APPEAL SUMMARY

Appeal ID: 21953

Building/Business Name: Tabor Commons

Section 713.4 Shaft Enclosures

**ENLARGED
PLANS
4TH FLR**

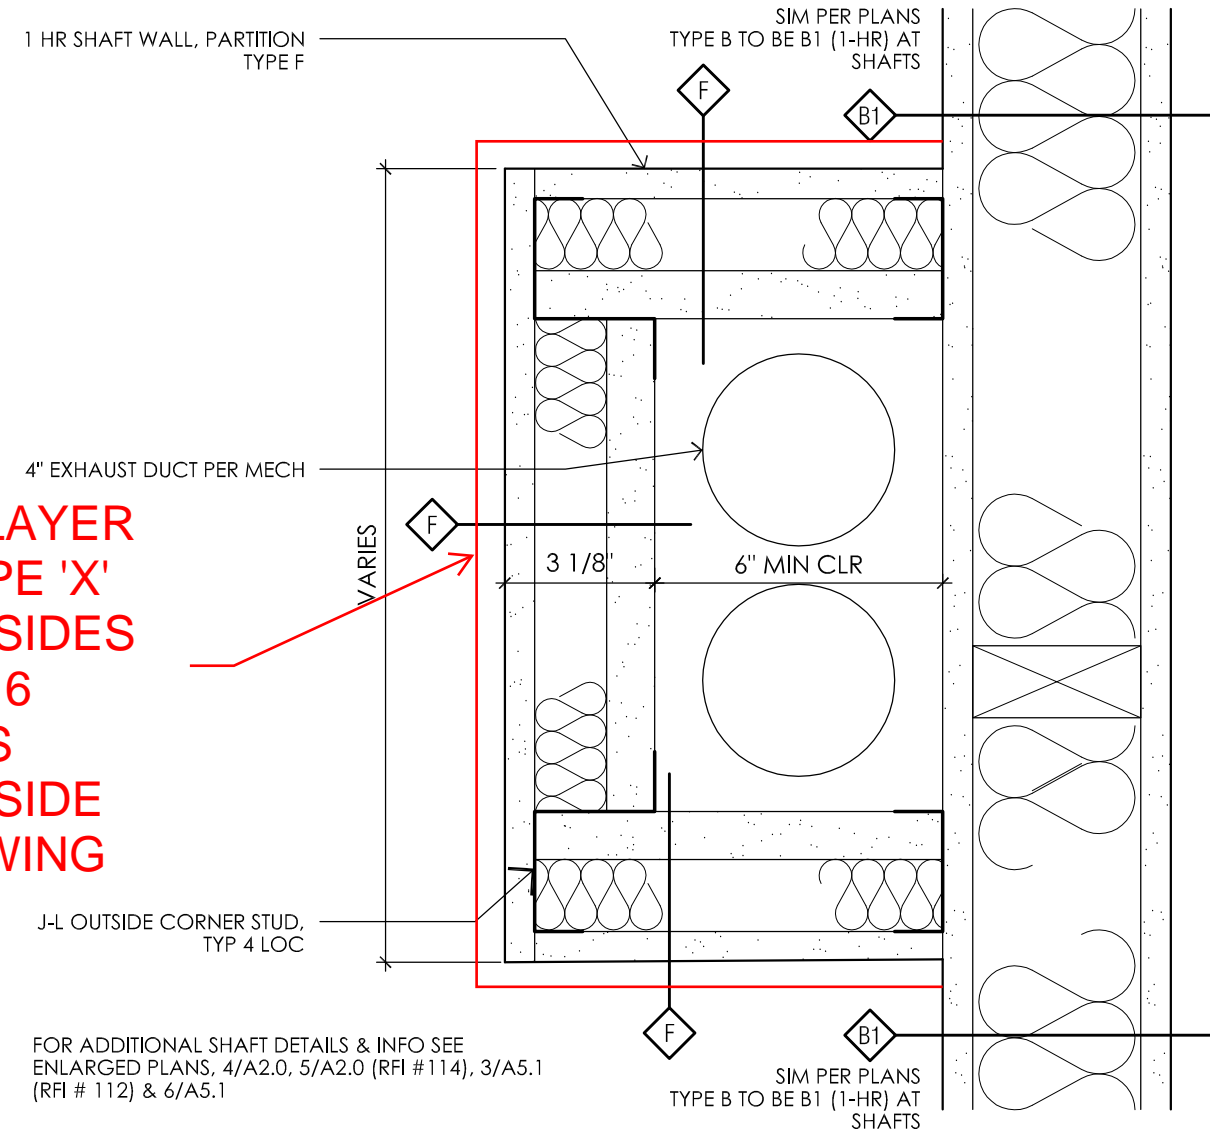
The south side of the west wing has four stories with four studio units and one sleeping unit per floor. At the first floor ceiling 9 exhaust fans & ducts feed into six shafts above (2 ducts per studio unit and 1 duct per sleeping unit). 1 hour shaft walls were installed per the approved permit drawings. As an alternate method the addition of 1 layer of 5/8" Type 'X' GWB to 3 sides of 4 shafts and 2 sides of 2 shafts is proposed as well as the addition of a dry sidewall sprinkler head at the top of each shaft. See the attached plans and details.

ADD 1 LAYER
5/8" TYPE 'X'
GWB 3 SIDES
TYP AT 6
SHAFTS
SOUTHSIDE
WEST WING

Alternate 2 hour fire rated shaft enclosures: Granted as proposed.

6 PLAN DETAIL AT TYP EXHAUST SHAFT
A2.0 3" = 1'-0"

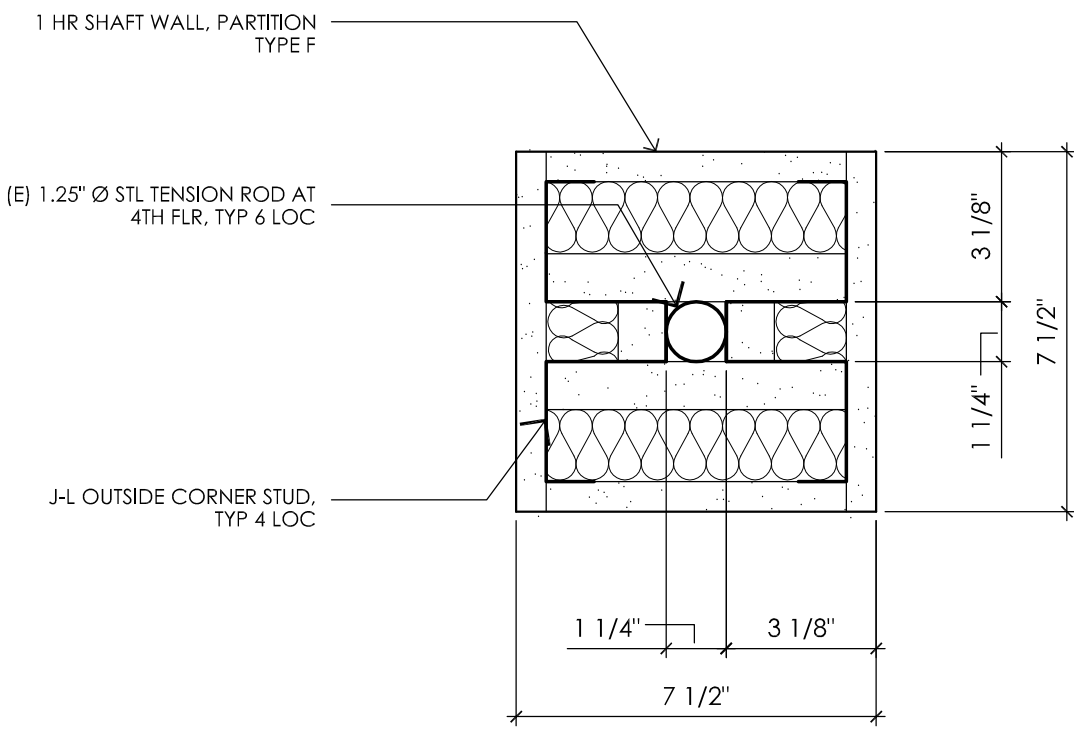
We believe the proposed design will provide equivalent fire protection. Around 75% of the shaft walls will have 2 hr protection with the additional layer of 5/8" Type 'x' GWB; see the attached Wall Type F, GA File No. WP 6905 with 1 hr rating and GA File No WP 7060 with 2 hr rating. The added dry sidewall sprinkler head at the top of each shaft should more than provide the remaining protection. See the attached plans and details.

6 UNIT EXHAUST SHAFT
A5.1 1 1/2" = 1'-0"

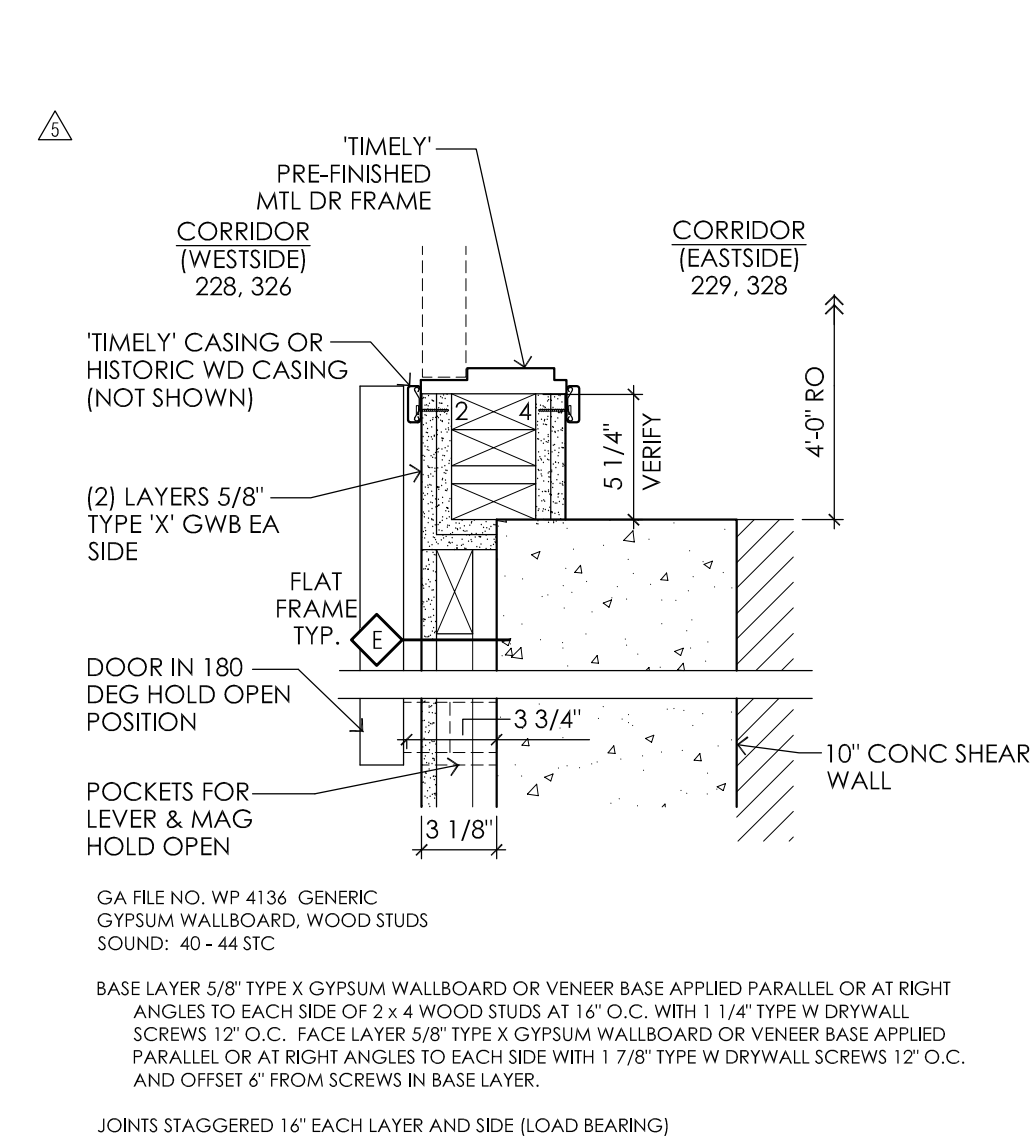
ADD 1 LAYER 5/8" TYPE 'X' GWB 3 SIDES TYP AT 6 SHAFTS SOUTHSIDE WEST WING
